Product Change Notification

Change Notification #: 113448 - 00
Change Title: Intel® Server System R2208GZ4GC
PCN 113448-00, Product Design
Update the System Rear Panel and
BIOS/ME/BMC/FRUSDR Firmware
Date of Publication: November 20, 2014

Figure One

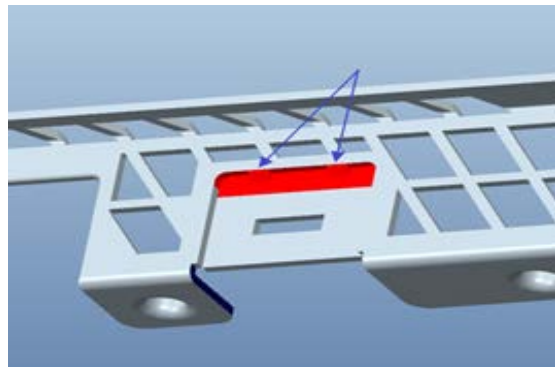
1. Update the one big center joint to two smaller joints so that the joints will not conflict with the LAN cable connector latch. See the Figure One.

Figure Two

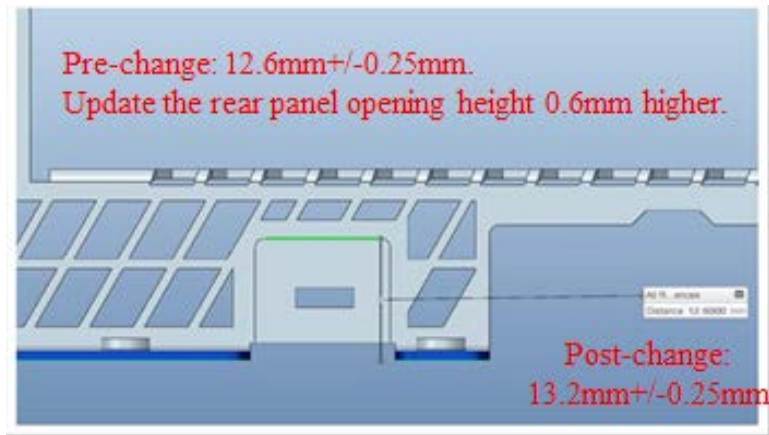
2. Update the rear panel opening height 0.6mm higher to improve the flexibility for the cable latch. The previous height was 12.6mm \pm 0.25mm. The updated height is 13.2mm \pm 0.25mm. See the Figure Two.

Figure Three

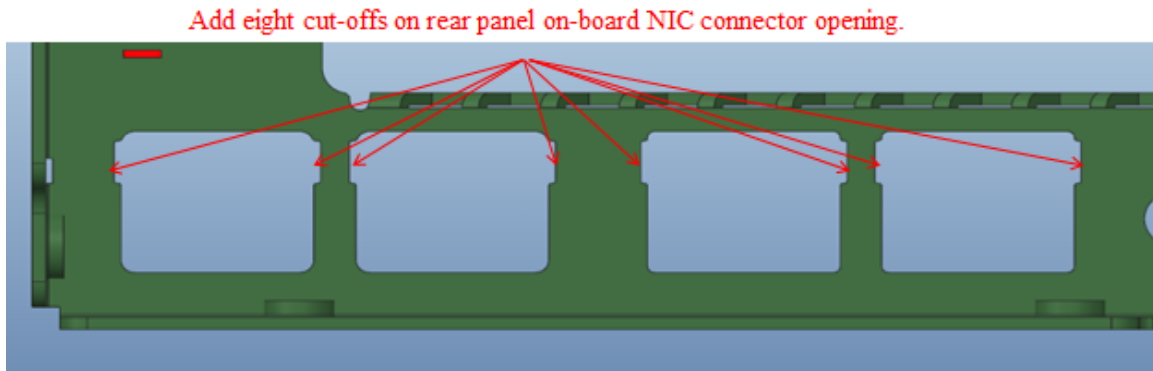
3. Add eight cut-offs around the on-board NIC (Network Interface Controller) openings to improve the LED visibility. See the Figure Three.
